Access Compliance Report

Public Rights-of-Way

Intersection ID: 2798	Main Street: BLACKBIRD_CT	Cross Street: CHAVEL_LN	Location:	N
ADA ID: F390A3E4A084	Ramp Type: Perp	Initial Pass/Fail: Fail	Overall Compliance: No	Severity Score: 25

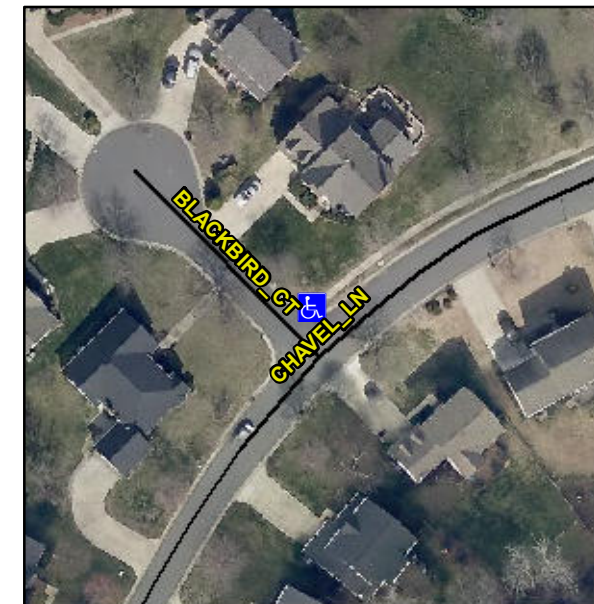
Not Found, R304.5.3

Compliance	Description	Data	Compliance	Description	Data
N/A	Ramp Length (in)	95.0	Yes	Ramp Slope (%)	5.5
Yes	Ramp Width (in)	48.0	No	Ramp XSlope (%)	7.1
N/A	Flare Type LT	N/A	N/A	Flare Type RT	N/A
N/A	Flare Slope LT (%)	N/A	N/A	Flare Slope RT (%)	N/A
N/A	Flare Traversable LT?	N/A	N/A	Flare Traversable RT?	N/A
N/A	Landing Length (in)	N/A	N/A	DWS Provided?	N/A
N/A	Landing Width (in)	N/A	N/A	DWS Contrast?	N/A
N/A	Landing Slope (%)	N/A	N/A	DWS Length (in)	N/A
N/A	Landing X Slope (%)	N/A	N/A	DWS Full Width?	N/A
N/A	Landing Curb? (Y/N)	N/A	N/A	DWS Offset (in)	N/A
N/A	Shared Landing?	N/A			
N/A	Gutter Ponding?	N/A	N/A	Gutter Slope (%)	N/A
N/A	Gutter Lip Ht (in)	N/A	N/A	Gutter X Slope (%)	N/A
N/A	Painted X Walk1?	No	N/A	Painted X Walk2?	N/A
	X Walk 1 Direction	To SW		X Walk 2 Direction	N/A
N/A	X Walk 1 Width (in)	N/A	N/A	X Walk 2 Width (in)	N/A
	X Walk 1 Slope (%)	5.2		X Walk 2 Slope (%)	N/A
	X Walk 1 X Slope (%)	1.7		X Walk 2 X Slope (%)	N/A

Remove & Replace Entire Ramp.
